RE: Chevron Service Station # 9-0121

Address 3026 Lakeshore Ave., Oakland, CA

Re: **Response to Comments**
Chevron Station 9-0121
3026 Lakeshore Avenue
Oakland, California
Fuel Leak Case No. RO000284

Conestoga-Rovers & Associates (CRA) has prepared this letter report in response to the ACDEH letter, dated July 27, 2007 (Attachment A), on behalf of Chevron Environmental Management Company (Chevron) for the site referenced above. The ACDEH letter requested the following:

Chevron service Station 9-0121
3026 Lakeshore Avenue Oakland

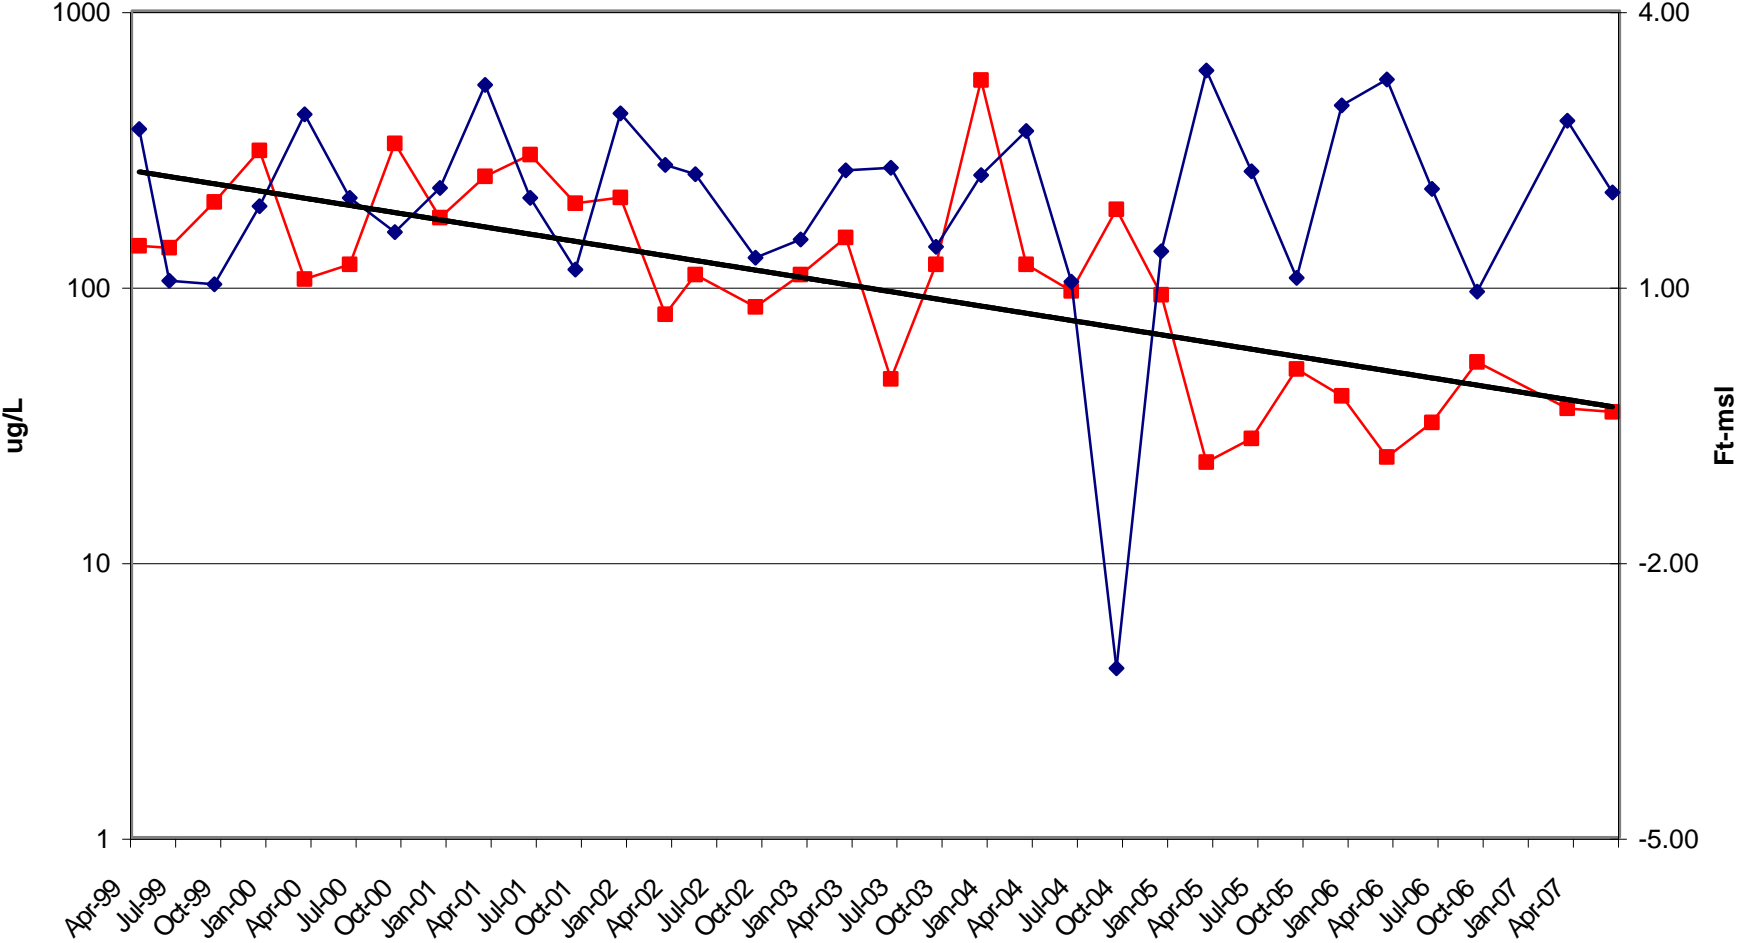
1. Off-site Building Impacts- Our office believes the presence of petroleum contaminated water in the neighboring building sump should be prevented by initiating on-site remediation at your site. Please provide options and your recommendation for remediation. Please verify that the current UST system is currently in compliance by contacting the OFD and reviewing the latest inspection reports for these USTs. Please submit these reports as requested below.
2. MW-7 Status- Monitoring well MW-7 has either been unable to be located or paved over for a long period of time. We request that you locate and properly decommission this well as it has and does not add any additional information or understanding to the site. Please indicate when this well will be decommissioned.

CRA and Chevron have reviewed the site data and believe that onsite remediation is not necessary due to decreasing hydrocarbon concentration trends observed in onsite wells, including both monitoring wells along the neighboring property line. Trend graphs for wells MW-1 and MW-9 are included in Attachment B.
